# GT40 Service Bulletin: 0702aGTB HVAC Blower Fan Relay Retrofit

## Supplement to Original Bulletin 0702GTB

1/08

Fig. 1a Relay Identification

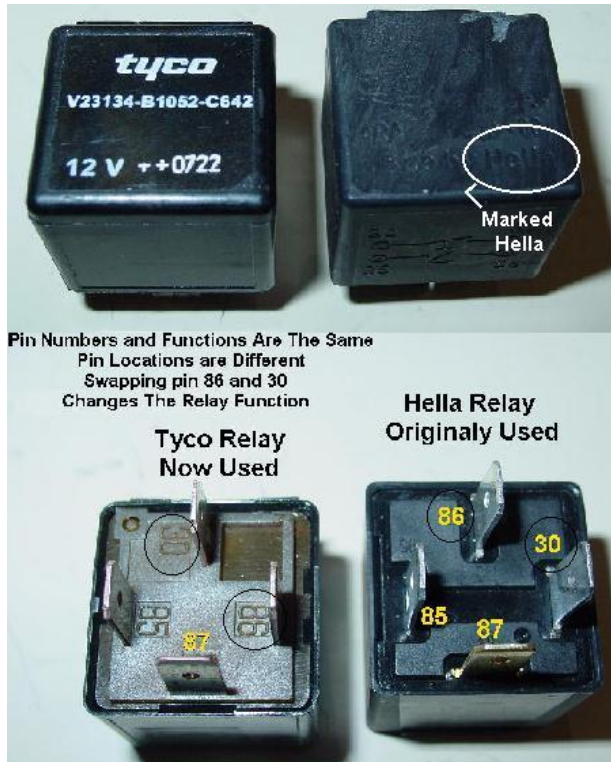
1. Identify that your harness has Tyco relays. If Hella relay are present the harness is wired correctly. Figure 1a illustrates the two different relays. Also shown if the pin

number location on the relays. This difference changes the relay function and prevents them from activating.

Fig. 2a Location of Connector to Swap

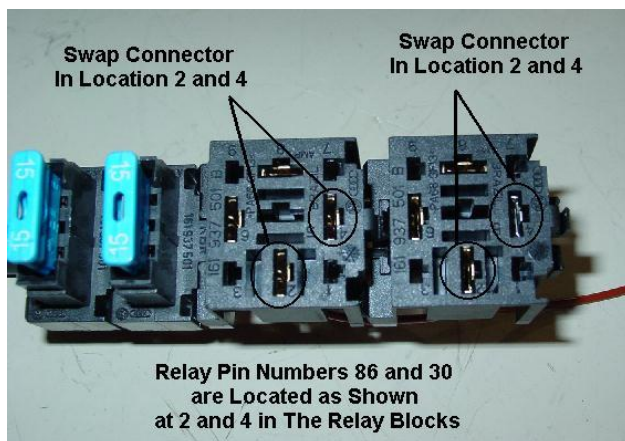
The harness can be made compatible by simply switching the 86 and 30 terminals for each relay.

2. To change the wiring for the Tyco relays, pin 86 and 30 must be swapped at the relay holder. Locations of these connectors are identified as 2 and 4 on the holder. (See Figure 2a) Wires in location 2 (moving to 4) must correspond with pin 86 on the relays. This is the brown ground wire that loops together. Wires in location 4 (moving to 2) must correspond with pin 30 on the relays. This is the red supply wire that also loops together.
